Public Service
Electric and Gas
Company

HOPE CREEK GENERATING STATION
DOCKET NO. 50-354
DRAFT SAFETY EVALUATION REPORT
OPEN ITEM STATUS

Public Service Electric and Gas Company hereby submits the enclosed responses to DSER open items and revised FSAR Section 13.2 for the Hope Creek Generating Station.

FIGURE 430.33-1

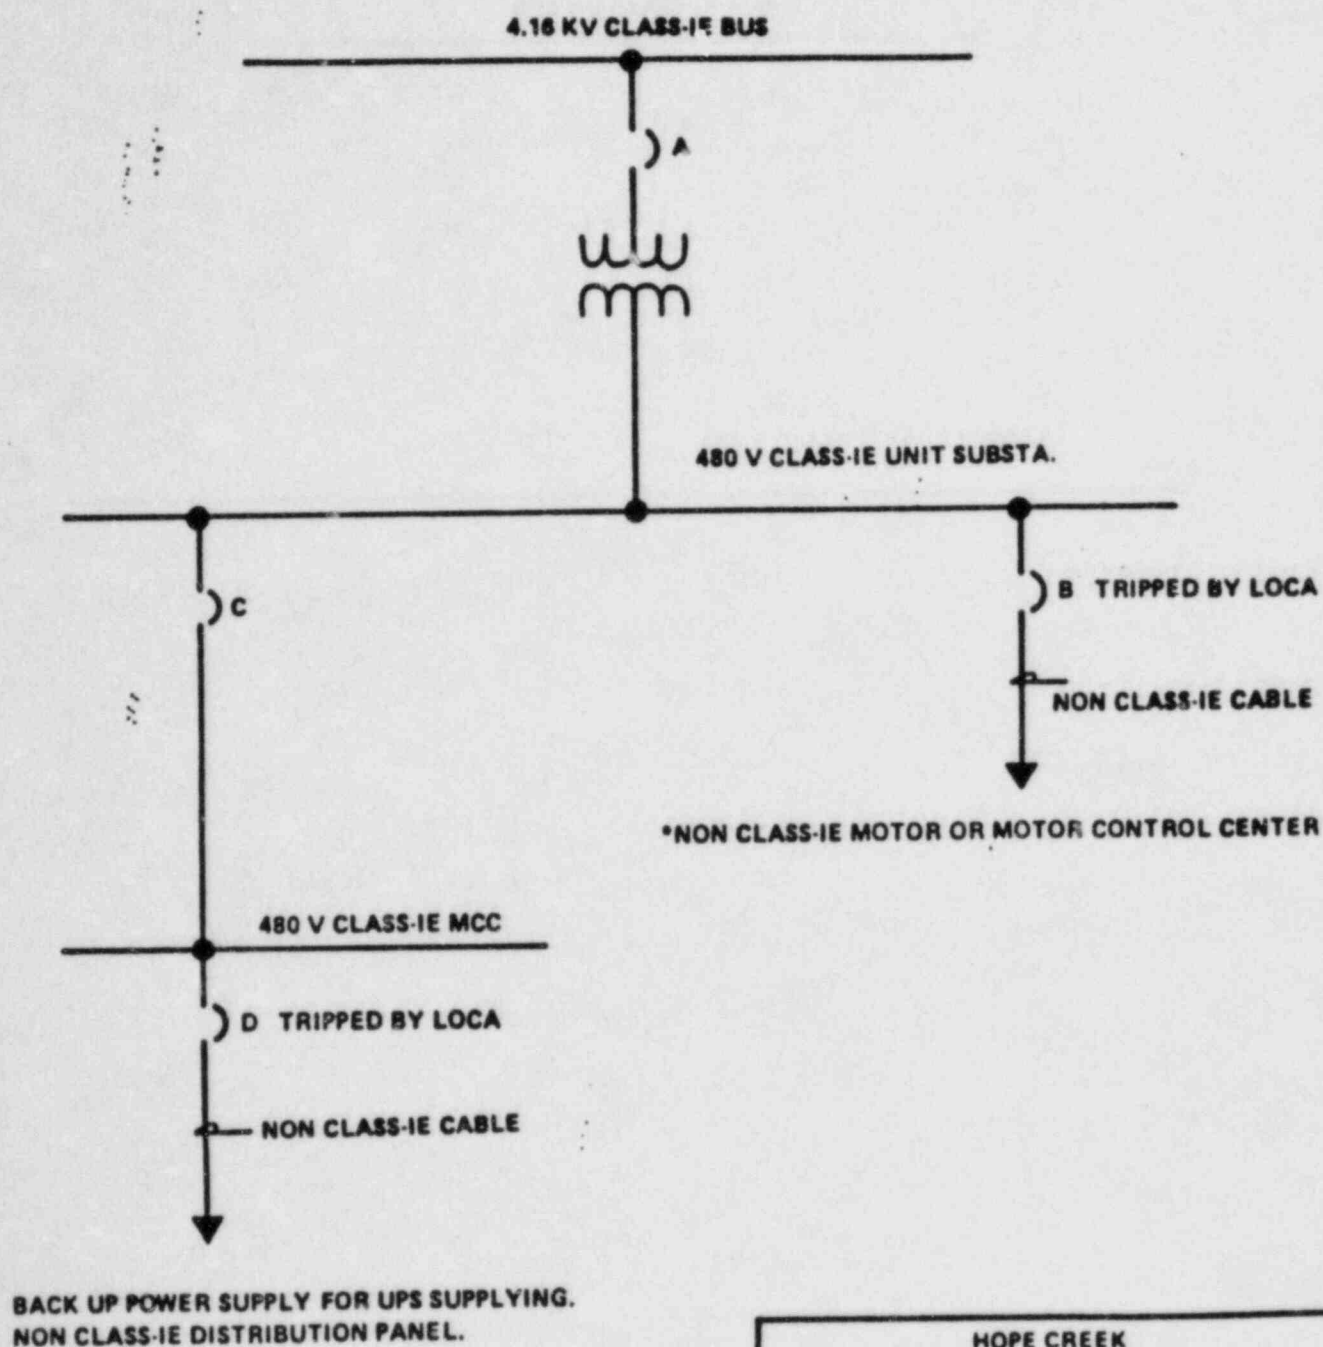
Question 430.33DSER Open Item No. 260 (DSER Section 8.3.3.3.3)THE USE OF A SINGLE BREAKER TRIPPED BY A LOCA SIGNAL AS AN ISOLATION DEVICE

By Amendment 4 to the PSAR, the applicant indicated that protective device coordination studies show that the single breaker time overcurrent trip characteristics will trip to clear a fault prior to initiation of a trip of a upstream breaker. Identification of all non-Class 1E circuits being isolated using a single breaker trip by LOCA signal, periodic testing of breaker coordination, and capability of breaker to trip prior to any versus only upstream breaker and for all versus only circuit faults, will be pursued with the applicant.

Response to Question 430.33 has been revised to provide the requested information.

Figure 430.33-1 shows the two configurations that employ a circuit breaker tripped by a LOCA signal as an isolation device. The two configurations are:

Protective device coordination studies for devices shown in Figure 430.33-1 have shown that the time-overcurrent trip characteristics of circuit breakers A, B, C, and D are such that:

Periodic testing of the breaker time-overcurrent trip
 characteristics will be performed to demonstrate that the
 circuit breaker trip function remains within required limits.
 Table 430.33-1 identifies the non-Class 1E loads that are
 supplied through circuit breakers B and D of Figure 430.33-1.
